# **Groundwater Application Review Summary Form**

Application # G- 18439	
GW Reviewer M. Thoma	Date Review Completed: 07.25-17
Summary of GW Availability and Injury Review:	
[ ] Groundwater for the proposed use is either over amounts requested without injury to prior water right capacity of the groundwater resource per Section B of	hts, OR will not likely be available within the
Summary of Potential for Substantial Interference F	
There is the potential for substantial interference	per Section C of the attached review form.
Summary of Well Construction Assessment:	
[ ] The well does not appear to meet current well co review form. Route through Well Construction and C	· · · · · · · · · · · · · · · · · · ·
This is only a summary. Documentation is attached of basis for determinations and for conditions that may

# PUBLIC INTEREST REVIEW FOR GROUNDWATER APPLICATIONS

ГО:			Rights S					Date	·:	July 25	5, 2017		
FROM:		Ground	dwater S	ection		Michae	el Thoma						
						Revie	ewer!s Name						
SUBJE	CT:	Applic	ation G-	18439		Sup	persedes i	review of					
											Date of Rev	view(s)	
PI IRI I	C INTI	REST	PRESII	MPTION;	GROUND	WATE	R						
								water use will e	nsure the	nrese	rva

Water-Level Trends in Nearby Wells

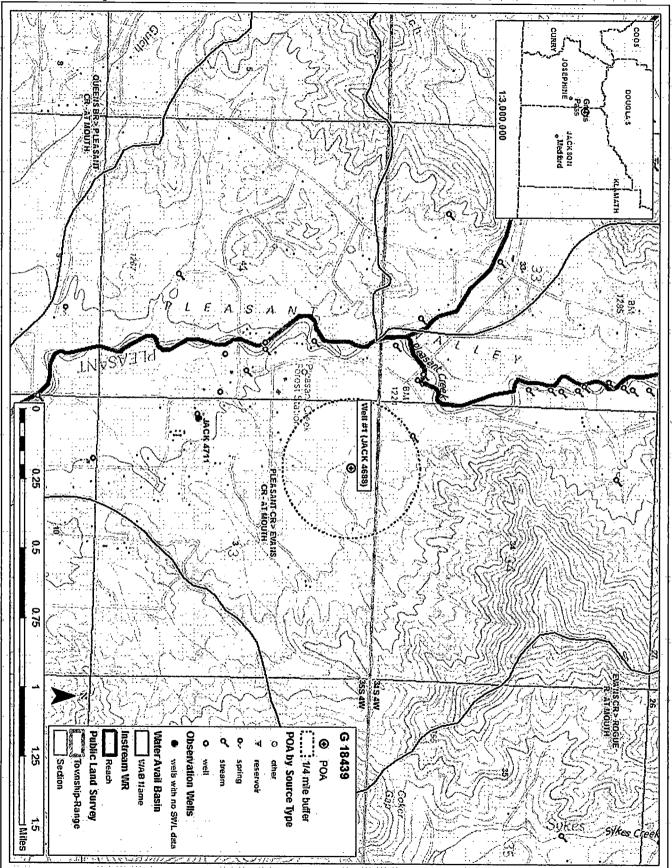
There are no observation well data in the area-

#### Stream-depletion Model Results

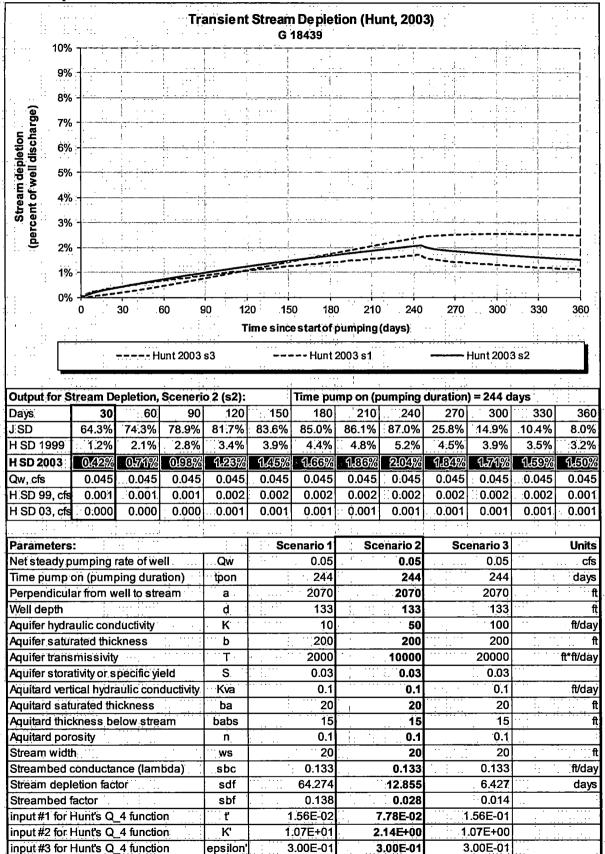
Comments: Interference @ 30 d was calculated using the Hunt (2003) stream-depletion model and aquifer parameter values that represent a fractured rock aquifer overlain by younger alluvial sediment. Model results are shown in Section E
